Subject: Westinghouse Comments on the Technical Basis for New Performance-Based Emergency Core Cooling System Requirements (Non-Proprietary)

**Westinghouse Comments on the Technical Basis for
New Performance-Based Emergency Core
Cooling System Requirements
(Non-Proprietary)**

Comments on the Aspects of the Adequacy of Technical Information in RIL 0801 and NUREG/CR-6967 Called Out in Federal Register Notice

Figure I-1. Achievable Pin Power vs. Burnup for Typical Westinghouse 3-loop PWR

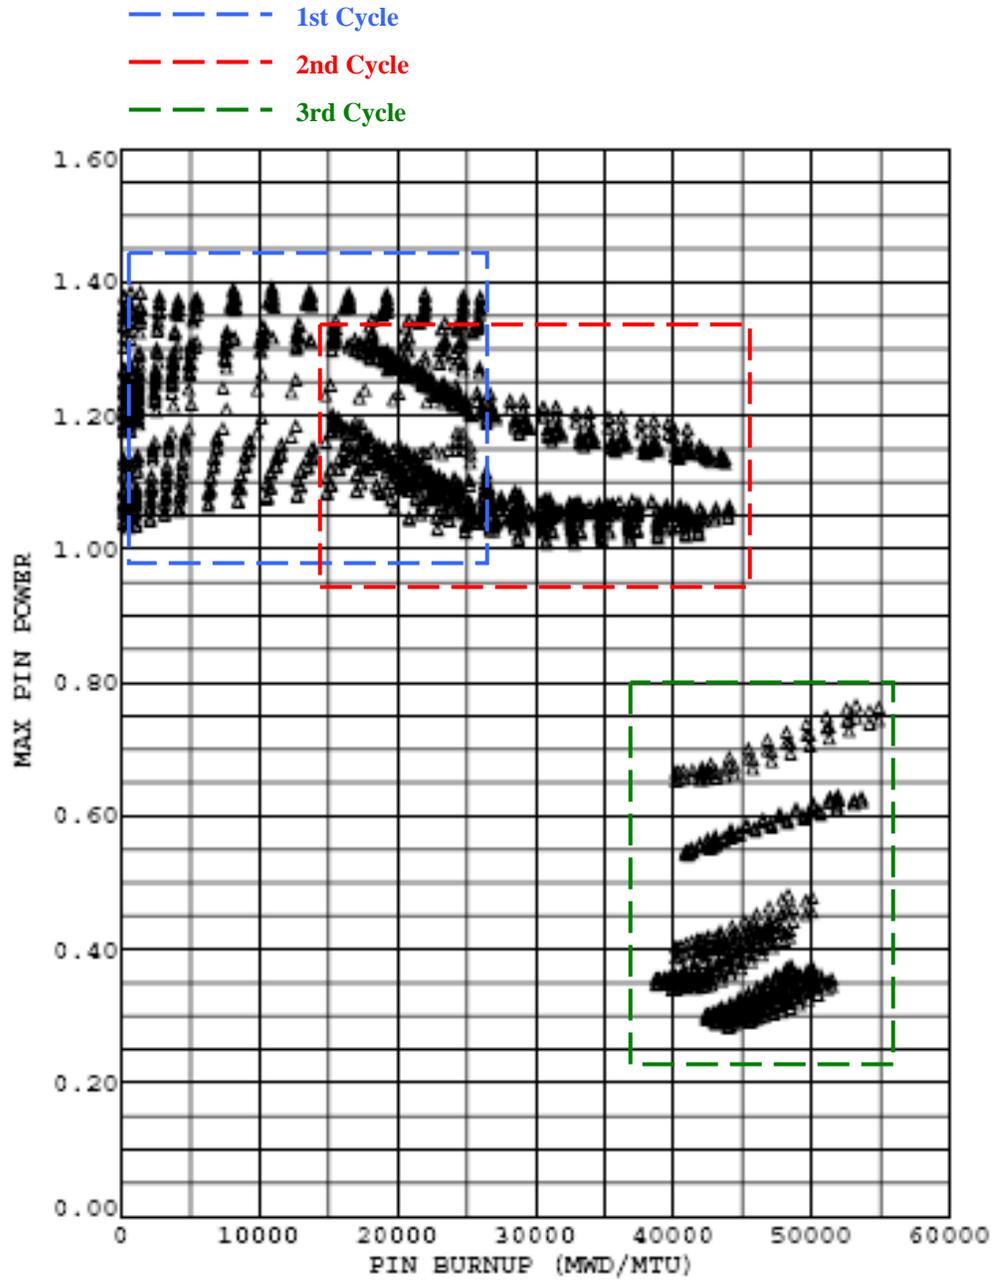
The technical information in NUREG/CR-6967 provides information on the behavior of current zirconium cladding alloys under bounding LOCA conditions. Unfortunately, since this work was done at bounding conditions, there has been no new information generated for hydrogen-charged or high-burnup materials under the temperature conditions which high-burnup fuel could attain in a reactor which satisfies the current 10 CFR 50.46 acceptance criteria for Emergency Core Cooling Systems. Uranium dioxide fuel limited to 5 weight percent U-235 cannot lead the core (in terms of achievable linear heat rates) after a burnup of between 25-30 GWD/MTU (Figure I-1). As burnup increases, the power decreases, and the peak cladding temperature and corresponding maximum local oxidation decrease accordingly, relative to the fresh fuel in the core. Prior studies (e.g., References 1 through 3) have shown on the order of 200°C or more reduction in peak cladding temperature for realistic high burnup fuel assessments.

Figure II-1. Typical Transient Temperature Transient Used in ANL LOCA Testing

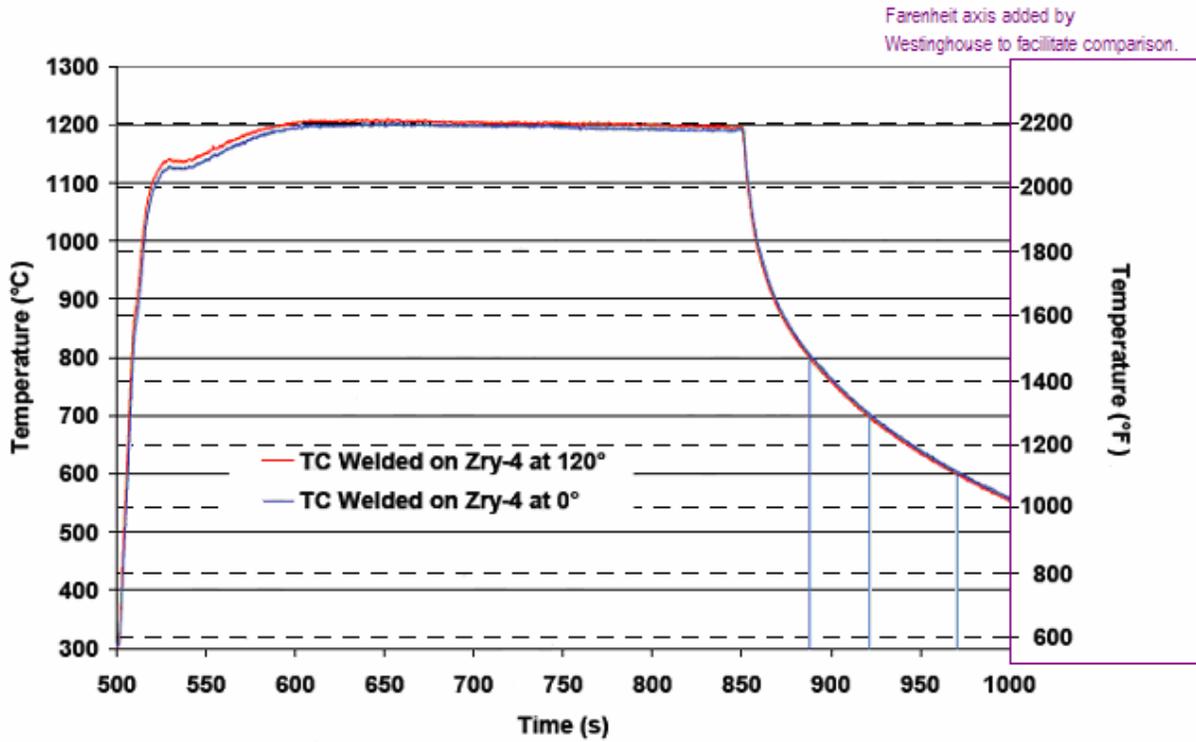
The transient temperature profile used in the ANL LOCA tests (Figure II-1) was sufficiently conservative to bound those expected for the fuel that is capable of achieving limiting linear heat rates. The initial heat-up rate from 300°C to ~1130°C (572°F to ~ 2070°F) is about 42°C/sec (75°F/sec), followed by a heat-up rate of ~ 10°C/sec (18°F/sec) to 1200°C. This bounds expected heat-up transients to the limiting temperatures in small and large break LOCAs. It is overly conservative for high-burnup fuel, as discussed in the comment on item I.1.a.

Figure II-2 Transient Temperature Profiles for a Sample Small Break LOCA

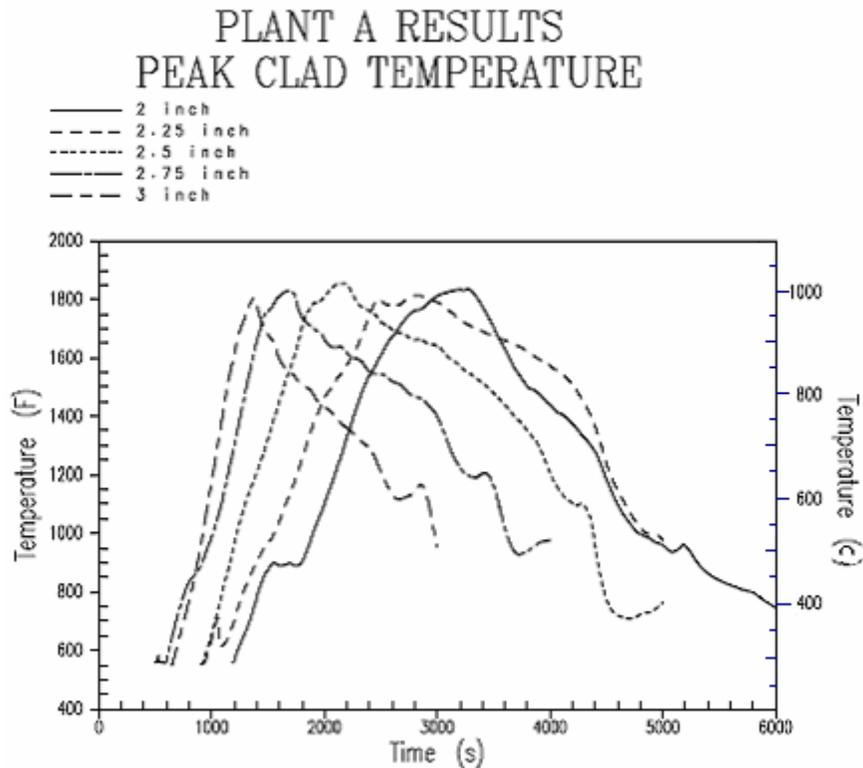
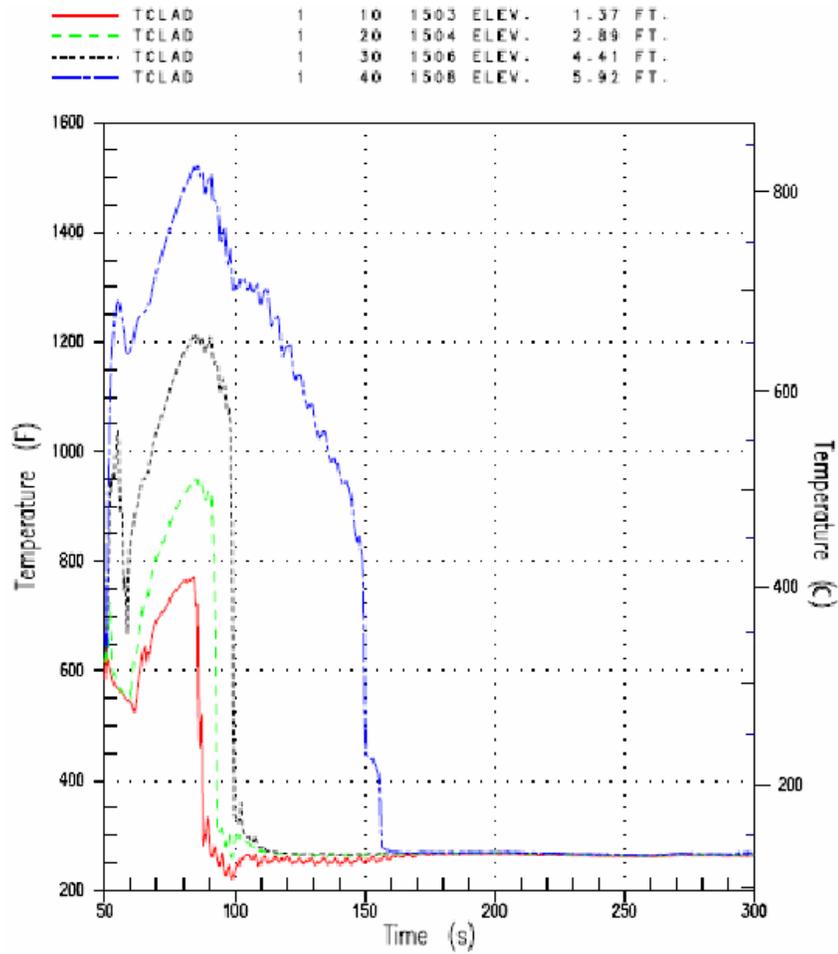
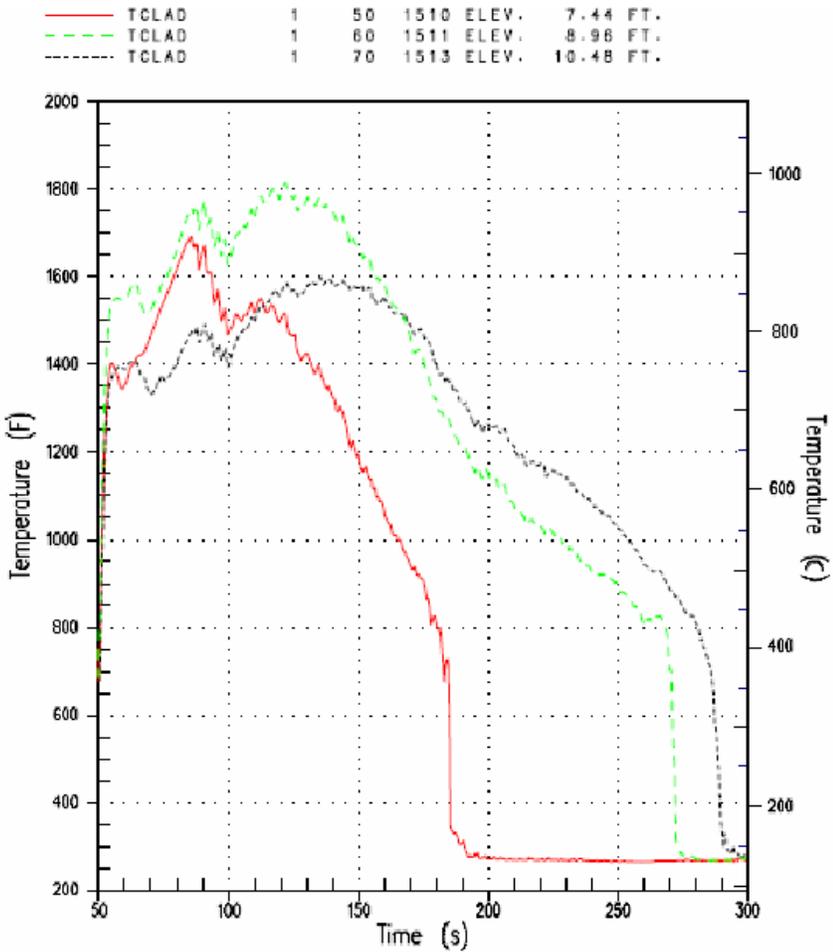
The temperature profiles seen in LOCA analyses of small and large break scenarios can vary widely. Sample temperature profiles are provided in Figures II-2 and II-3. The few “generic” comments that can be made are as follows:

- *Small break heat-up rates (~ 2-5°F/sec) are noticeably lower than for large break events (~10-15°F/sec), and the time at elevated temperature is longer (but at lower temperatures).*
- *Large break LOCAs can quench at somewhat higher temperatures at low elevations due to the heat transfer mechanisms involved (e. g., inverted annular film boiling at the bottom of the core vs. dispersed flow film boiling higher in the core). Note that the limiting elevations for corrosion are in the high elevations of the core.*
- *It is Westinghouse experience that the heat-up rates used in the ANL LOCA tests bound those observed in small and large break LOCAs, and that a quench temperature of 800°C bounds those reasonably expected by a considerable amount.*
